# Access Compliance Report

## Public Rights-of-Way

### (Curb Ramps)

Intersection ID: 10020376	Main Street: BALLANTYNE_CORPORATE_PC	Cross Street: N/A	Location: SW
ADA ID: B71E570A28D8	Ramp Type: Perp	Initial Pass/Fail: Fail	Overall Compliance: No
Severity Score: 10			
Codes/Mitigation Info/Possible Solution		Field Measurements/Component Compliance

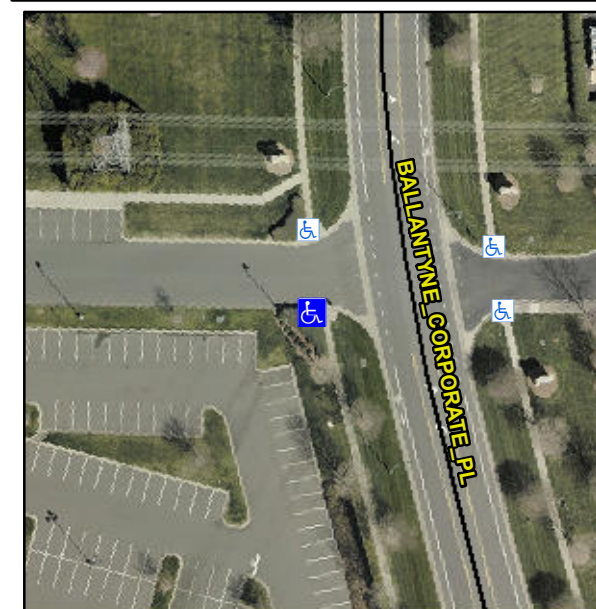
**Not Found, R304.5.1, R304.5.3**

Compliance	Description	Data	Compliance	Description	Data
N/A	Ramp Length (in)	58.0	Yes	Ramp Slope (%)	6.5
No	Ramp Width (in)	42.0	No	Ramp XSlope (%)	2.4
N/A	Flare Type LT	N/A	N/A	Flare Type RT	N/A
N/A	Flare Slope LT (%)	N/A	N/A	Flare Slope RT (%)	N/A
N/A	Flare Traversable LT?	N/A	N/A	Flare Traversable RT?	N/A
N/A	Landing Length (in)	N/A	N/A	DWS Provided?	N/A
N/A	Landing Width (in)	N/A	N/A	DWS Contrast?	N/A
N/A	Landing Slope (%)	N/A	N/A	DWS Length (in)	N/A
N/A	Landing X Slope (%)	N/A	N/A	DWS Full Width?	N/A
N/A	Landing Curb? (Y/N)	N/A	N/A	DWS Offset (in)	N/A
N/A	Shared Landing?	N/A			
N/A	Gutter Ponding?	N/A	N/A	Gutter Slope (%)	N/A
N/A	Gutter Lip Ht (in)	N/A	N/A	Gutter X Slope (%)	N/A
N/A	Painted X Walk1?	No	N/A	Painted X Walk2?	N/A
	X Walk 1 Direction	To N		X Walk 2 Direction	N/A
N/A	X Walk 1 Width (in)	N/A	N/A	X Walk 2 Width (in)	N/A
	X Walk 1 Slope (%)	3.9		X Walk 2 Slope (%)	N/A
	X Walk 1 X Slope (%)	1.0		X Walk 2 X Slope (%)	N/A

**Remove & Replace Entire Ramp.**
